# **CAPRICORN MUNICIPAL DEVELOPMENT GUIDELINES**

# **2025 MEETING 1 MINUTES**

Date and Time: 13<sup>th</sup> February 2025 at 11:00 am

ESC Plan

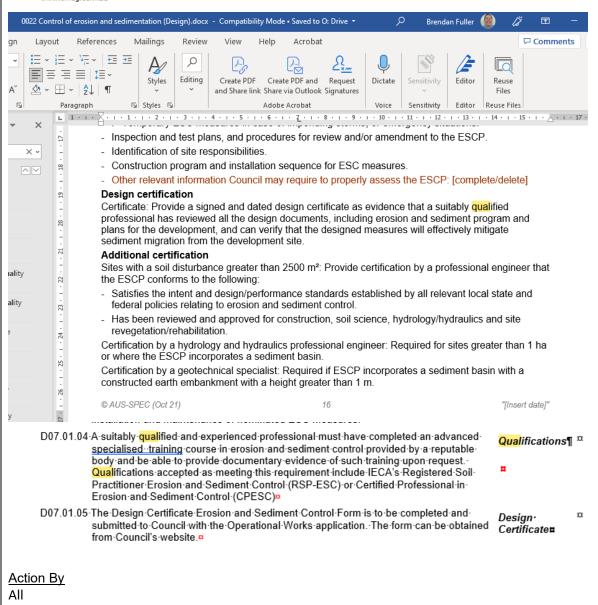
- MCE and LGAs to review RRC's guide ESCP plan and D7.
- Confirmation of requirements at each stage is needed (MCU/ROL vs OPW vs prior to prestart).

- Reading the Natspec specification 0022 it has well defined certification requirements depending on the separate contexts.
- "Design certification" only has to be a "suitably qualified professional" then "additional certification" has three types of professional engineers depending on what is to be undertaken.

- CMDG D5 simply states "RPEQ or CPESC" which may be interpreted as a CPESC would be able to certify items that Natspec classes as "additional certification" as they are not excluded.
- May be worth reviewing the wording/ requirements.
- The proposed D7 changes thing again by not even mentioning the three types of professional engineers depending on what is to be undertaken.
